Historic Preservation Commission Meeting

| PROJECT: | COFA-03-25-019657 36 Wharf Street Two-story Carriage House – Under Construction |

An amended Certificate of Appropriateness-HD (COFA-HD) to allow the installation of alternate exterior doors. The property is in Old Town Bluffton Historic District, and zoned Neighborhood General-HD (NG-HD).

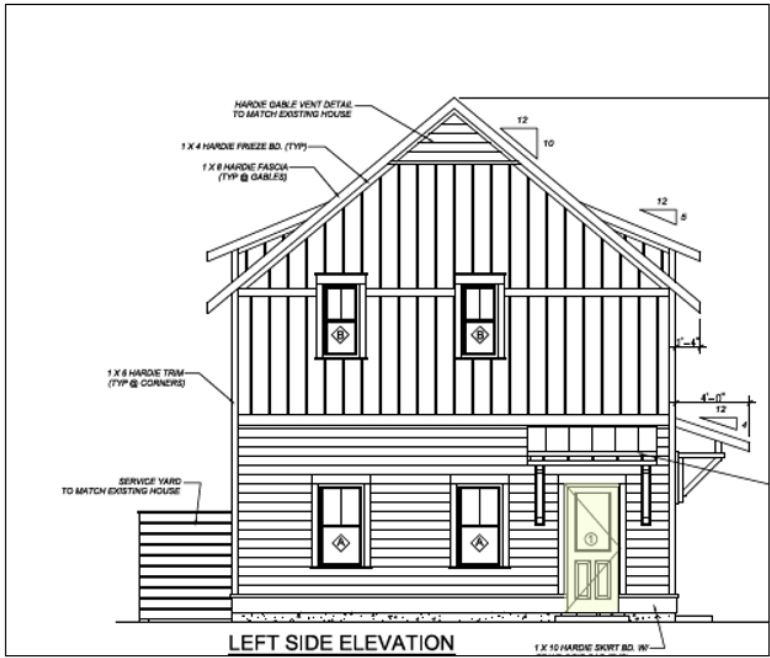
While conducting a rough inspection, Town Staff identified inconsistencies with the approved COFA, including: 1) installation of an unapproved man door opening on the right elevation; 2) installation of a full-lite door with built-in Venetian blinds on the left elevation; and, 3) installation of a full lite 4-lite door at the second-story right elevation. A six-panel door (a square/vertical combination) for the garage man door had not yet been installed at time of inspection.

Right Elevation

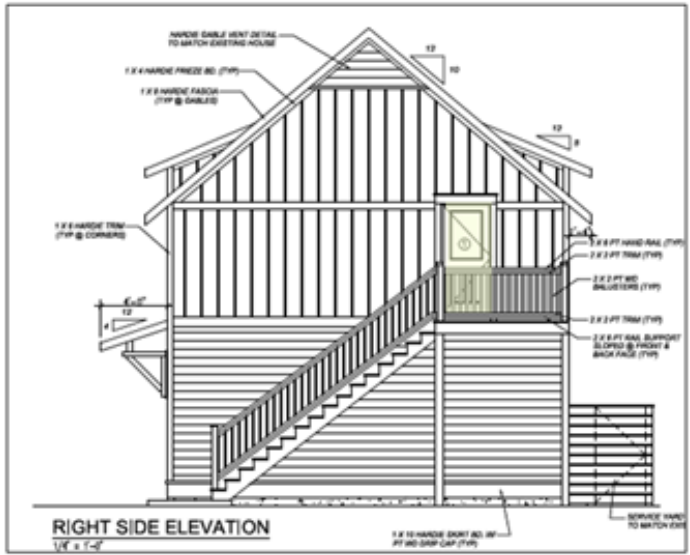
The approved COFA did not include a garage man door opening. The approved door on the left elevation was a metal-clad half-lite door. On the right elevation, the same metal-clad half-lite door was also approved.

The graphics on the following page show the left and right carriage house elevations and the carriage house with the installed doors (except for the garage man door). These can

- a. *Finding.* The Old Town Master Plan initiatives included the adoption of a form-based code with architectural standards for structures within the Old Town Bluffton Historic District. These standards are included in Article 5 of the UDO and are intended to ensure the application of traditional architecture and features, as well as authentic materials that are consistent with Old Town's vernacular. The left elevation door with full-lite inset blinds is not a traditional door configuration for Old Town. Further, the second story door is inconsistent and is a full lite door with 4-lites without the traditional panel commonly used in Old Town. For the garage man door, the square/vertical panel combination is also atypical.

Left Elevation

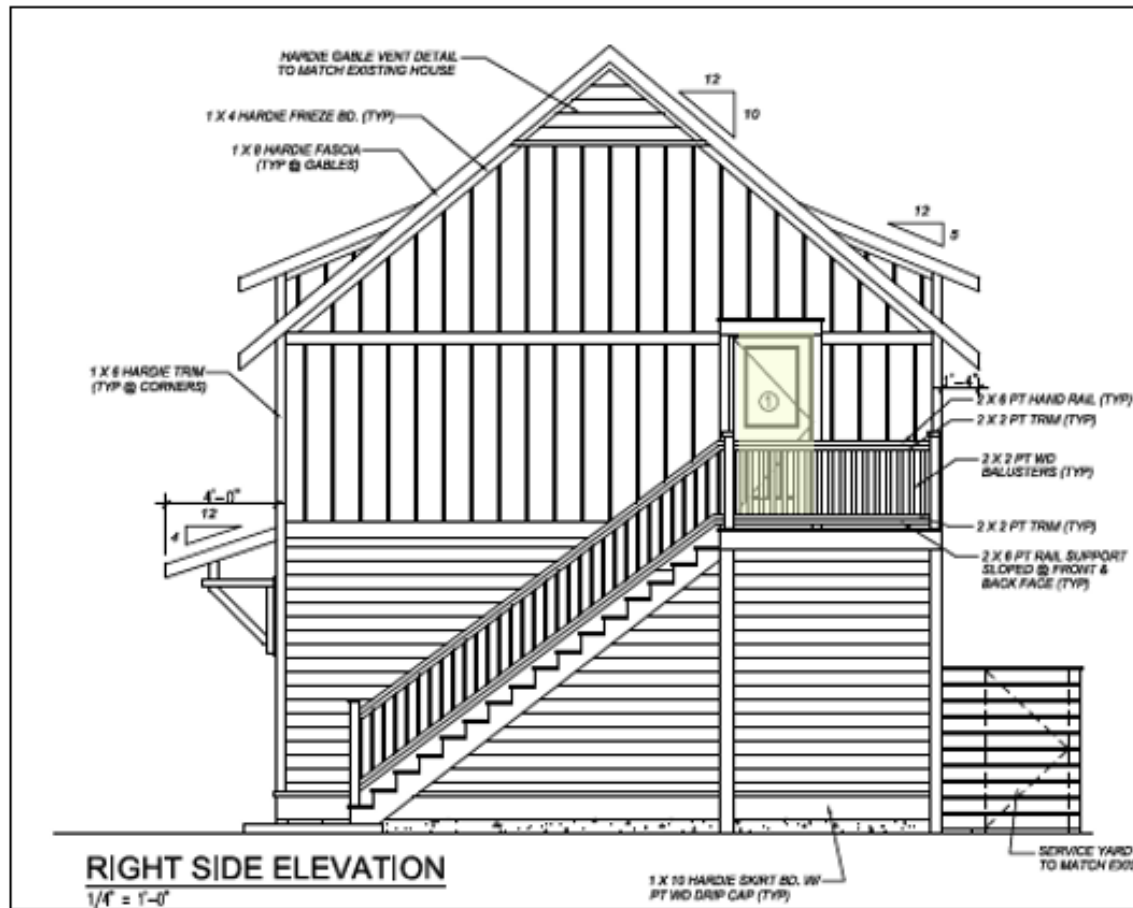
Finding. UDO Sec. 5.15.6 states that the "primary goal of [the Old Town Bluffton Historic District architectural standards] is authenticity. The standards encourage Bluffton vernacular and construction which is straightforward and functional, and which draws its ornament and variety from traditional assembly of genuine materials." As referenced in Finding #1, the proposed doors suggest configurations that are not common of Old Town's residential doors. Therefore, determinations of appropriateness for these doors are sought from the HPC.
